Access Compliance Report

Public Rights-of-Way

(Curb Ramps)

Intersection ID: 9172	Main Street: E_CRAIGHEAD_RD	Cross Street: N_TRYON_ST	Location: NE
ADA ID: 4778C22AE8C2	Ramp Type: Perp	Initial Pass/Fail: Fail	Overall Compliance: No
Severity Score: 21.25			
Codes/Mitigation Info/Possible Solution		Field Measurements/Component Compliance

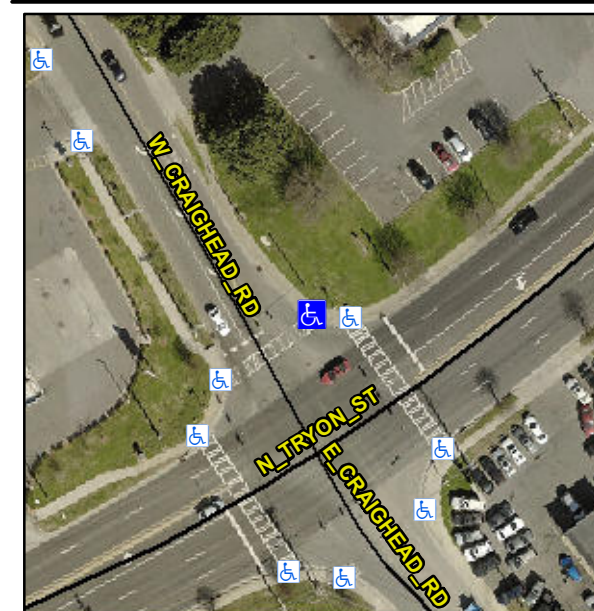
Not Found, R304.5.1, R304.2.2

Compliance	Description	Data	Compliance	Description	Data
N/A	Ramp Length (in)	72.0	No	Ramp Slope (%)	8.7
No	Ramp Width (in)	38.0	Yes	Ramp XSlope (%)	0.4
N/A	Flare Type LT	N/A	N/A	Flare Type RT	N/A
N/A	Flare Slope LT (%)	N/A	N/A	Flare Slope RT (%)	N/A
N/A	Flare Traversable LT?	N/A	N/A	Flare Traversable RT?	N/A
N/A	Landing Length (in)	N/A	N/A	DWS Provided?	N/A
N/A	Landing Width (in)	N/A	N/A	DWS Contrast?	N/A
N/A	Landing Slope (%)	N/A	N/A	DWS Length (in)	N/A
N/A	Landing X Slope (%)	N/A	N/A	DWS Full Width?	N/A
N/A	Landing Curb? (Y/N)	N/A	N/A	DWS Offset (in)	N/A
N/A	Shared Landing?	N/A			
N/A	Gutter Ponding?	N/A	N/A	Gutter Slope (%)	N/A
N/A	Gutter Lip Ht (in)	N/A	N/A	Gutter X Slope (%)	N/A
N/A	Painted X Walk1?	Yes	N/A	Painted X Walk2?	N/A
	X Walk 1 Direction	To SW		X Walk 2 Direction	N/A
N/A	X Walk 1 Width (in)	80.5	N/A	X Walk 2 Width (in)	N/A
	X Walk 1 Slope (%)	0.0		X Walk 2 Slope (%)	N/A
	X Walk 1 X Slope (%)	0.3		X Walk 2 X Slope (%)	N/A

Remove & Replace Entire Ramp.
